# UNITED STATES PATENT AND TRADEMARK OFFICE

# Office Action Summary

09/971,763

KIM ET AL.

FIG. 17

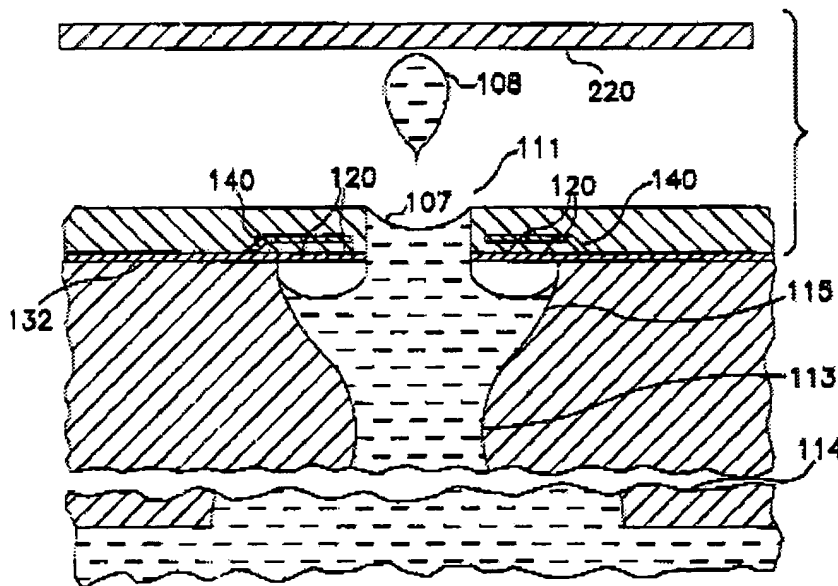
Silverbrook teaches (Fig. 17, above) an ink jet print head comprising a base plate (130), which is perforated by an hour-glass shaped structure having a hemispherical shaped top portion that is filled with ink, a nozzle plate that is mounted on the base plate and is perforated by a plurality of orifices in communication with their respective chambers, a plurality of dough-nut shaped heaters (120) disposed on the underside of the nozzle plate and surrounding each nozzle and a plurality of circular ink inlet passages (113), which supply ink from a reservoir to the hemispherical hour-glass shaped chamber. As can be seen Fig. 18 (which is a reverse structure of Fig. 17), each hemispherical chamber is connected to a funnel shaped chamber (489). Since Fig. 18 is a reverse of Fig. 17, these funnel shaped chambers would be found beneath the hemispherical chambers of Fig. 17. Silverbrook further teaches that that the chamber is disposed between the ink inlet passages and the orifices, that the ink inlet is connected to respective ones of the chambers and that the ink inlet has a diameter that is much smaller than the diameter of the chambers. Since the diameter of the inlet is much smaller than the diameter of the chamber, the inlet would have a smaller volume of ink than the chamber.

Silverbrook teaches the claimed invention with the exception of the ink inlet passages each having a plurality of grooves formed at an inner wall, the plurality of grooves extending through the base plate, the plurality of grooves being formed over an entire portion of said inner wall and the plurality of grooves extending in a direction parallel to a direction through said substrate and the grooves being formed around the entire circumference of the ink passages.

It would have been obvious to one of ordinary skill in the ink jet art at the time the invention was made to have provided Silverbrook with an ink inlet passage having a plurality of grooves formed in its walls, such that the grooves cover an entire portion of the wall, in a direction parallel to the ink flow direction (which is through the substrate), for the purpose of improving the flow of ink by allowing the ink to flow past an obstruction, as taught by Koto.
